FINAL ENVIRONMENTAL ASSESSMENT

FOR
INSTALLATION OF 8-INCH WATER MAIN
BETWEEN THE PALOLO CHLORINATOR
AND PALOLO TUNNEL, AND FROM
KUAHEA STREET TO WILHELMINA RISE
811 STORAGE RESERVOIR

Prepared for:
Board of Water Supply
City & County of Honolulu
630 South Beretania Street
Honolulu, HI 96813

JULY 1995

TYPICAL PIPE SUPPORT DETAIL

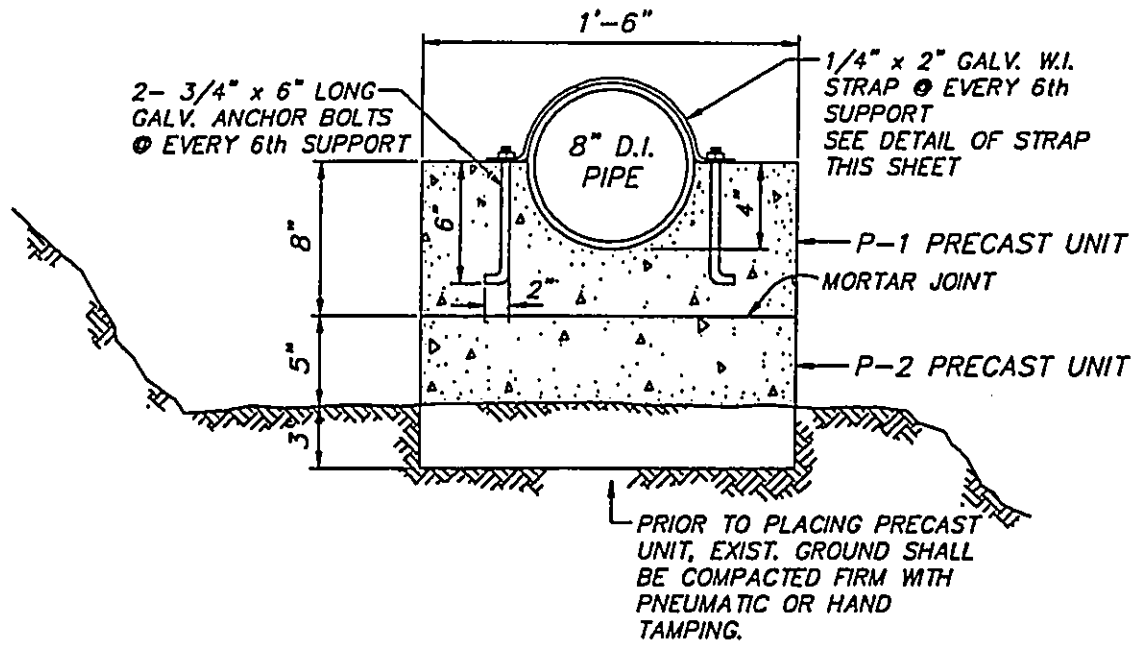
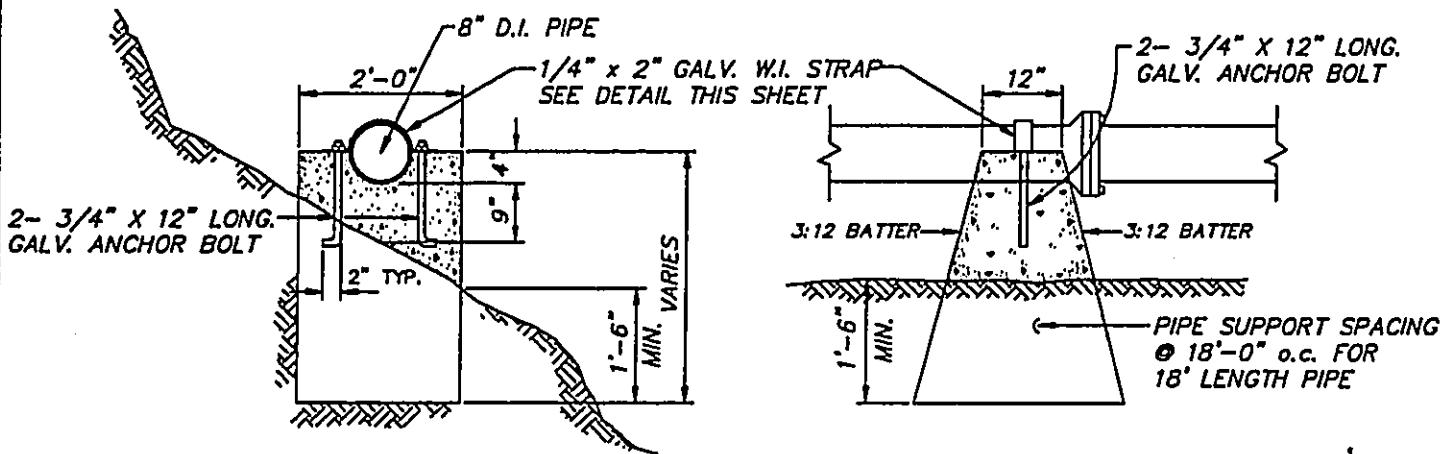
Request addition of typical sections for both above and underground installation of pipe.
